UNITED STATES PATENT AND TRADEMARK OFFICE

APPLICATION NO.	FILING DATE	FIRST NAMED INVENTOR	ATTORNEY DOCKET NO.	CONFIRMATION NO.
10/578,455	05/08/2006	Geoffrey Harding	DE 030381	6997
24737 7590 10/03/2007 PHILIPS INTELLECTUAL PROPERTY & STANDARDS P.O. BOX 3001 BRIARCLIFF MANOR, NY 10510			EXAMINER THOMAS, COURTNEY D	
			ART UNIT 2882	PAPER NUMBER
			MAIL DATE 10/03/2007	DELIVERY MODE PAPER

Office Action Summary

DETAILED ACTION

Figure 1 – Inspection Apparatus – U.S. Patent No. 3,936,638 to Gibbon

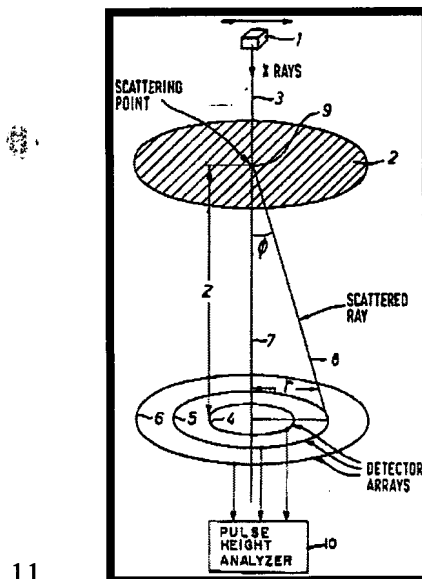
12. As per claims 1, 11 and 17, Gibbons discloses an apparatus (and corresponding method) comprising: a source of radiation (1) and detector (4-6); wherein the source of radiation produces radiation (X-Rays) sufficient to penetrate an object (2) of interest; wherein the object (2) causes secondary radiation (Scattered Ray - 8) as a first radiation (3) interacts with the object (2); the detector (array 4-6) is stationary during a scan and detects the scattered radiation; the source of radiation (1) is displaceable during a scan (see Fig. 1, shown above; see also 2:12-28)
